REMARKS

JSSN 09/512,085
Amdt. Dated 5/7/04
Reply to Action of 3/23/04
Annotated Sheet Showing Changes

Figure 7

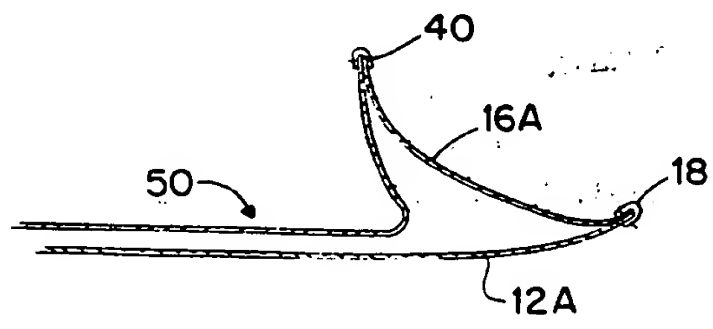
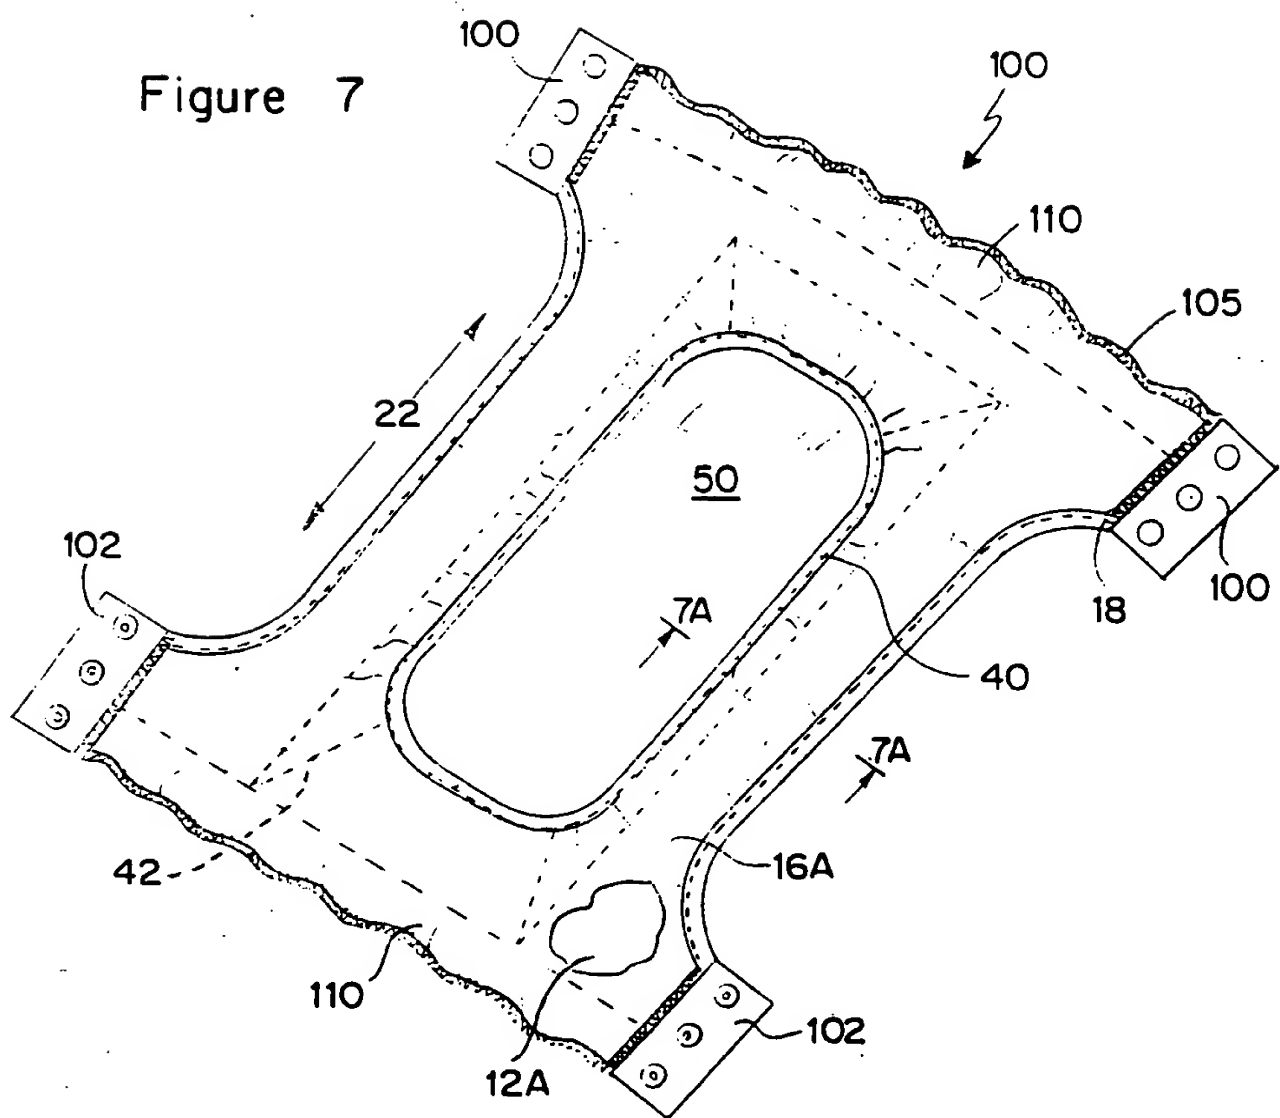
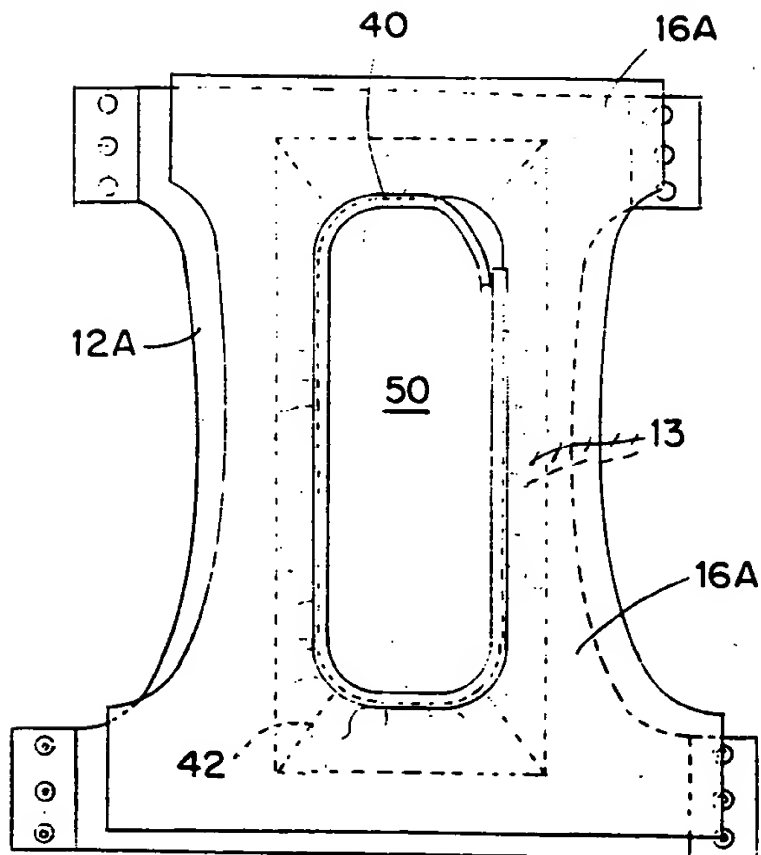
The drawings are amended per recommendations set forth in numbered paragraph 4 of the Office Action. Corrected drawings, together with a marked up copy, are submitted herewith. The corrected drawings are considered also to address the ground of non-approval of drawings presented on 12-19-03, as noted in numbered paragraph 3.
